Re: Proposed Modification of Project Approval – Early Contractor Involvement Detailed Design Adjustments - Intermodal Logistics Centre at Enfield (Application No 05_0147)

**ILC AT ENFIELD
 SITE LAYOUT**

DRAFTED BY: JT, AK	DATE: 05/03/2012	PLAN SCALE: AS SHOWN SCALE BAR
PROJECT CODE: ILC-E-G-MOD 6 SITE LAYOUT	DWG NO: SEDP181A

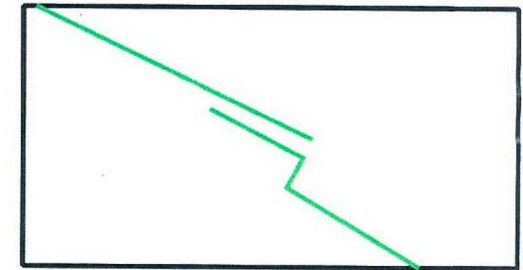
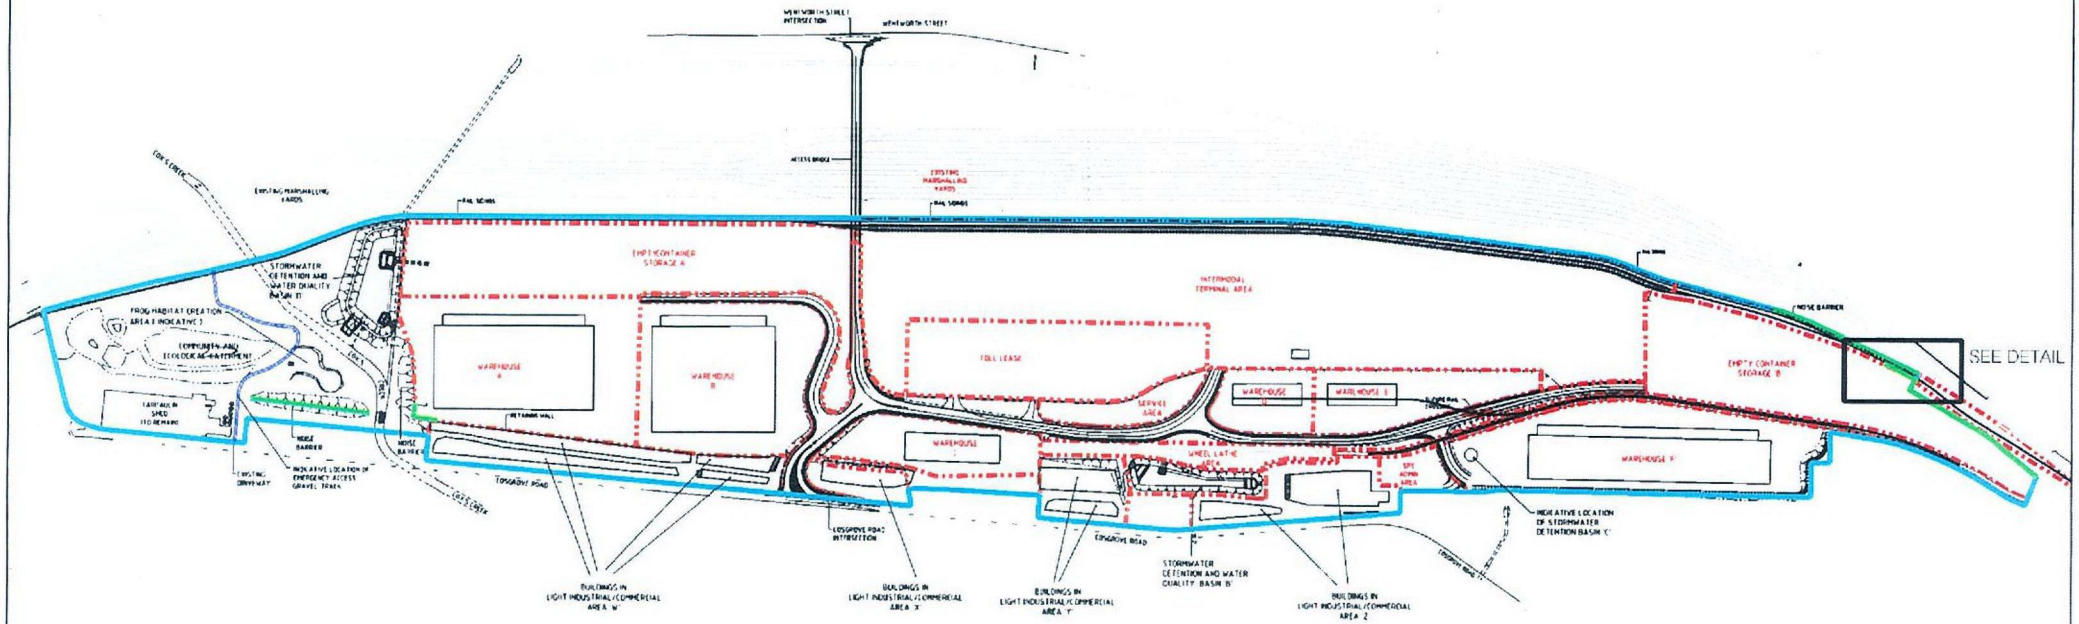
- Site Layout Design Adjustments (refer to attached drawing SEDP181A) including

- Changes in the layout of the Light Industrial Commercial (LIC) Area and their buildings, including an approximate 5% increase in the maximum gross floor area and a reduction of the setback distance of LIC area W from 10m to 8m

- Relocation of Stormwater Detention Basins B and D to allow a more efficient use of the existing site topography conditions and reduce cut and fill requirements during construction.

- Adjustments in the layout of the Service Area, Intermodal Terminal and Empty containers Storage Area A
 - Adjustments to the layout of the noise walls to take into account the precinct layout changes and operational conditions

- Subdivision of the site precincts
 - Changes in the wording of conditions 2.4(b) and 2.20/3.1 to provide flexibility with the requirement to close of the median strip on the Hume Highway at Como Road, Greenacre, and in the use of the project's meteorological station.
